## Public Comment No. 33-NFPA 780-2024 [ Section No. 1.1.1 ]

## Public Comment No. 28-NFPA 780-2024 [ Section No. 1.6 ]

#### Figure A.4.15.2.5.1 Illustration of Bonding Distance.

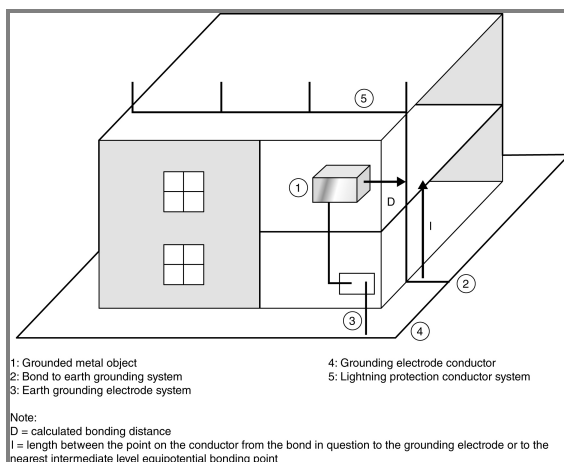
See Figure A.4.15.2.5.1 for an illustration of bonding distance.

## Statement of Problem and Substantiation for Public Comment

**Statement:** The figure did not accurately depict the application of the formula.
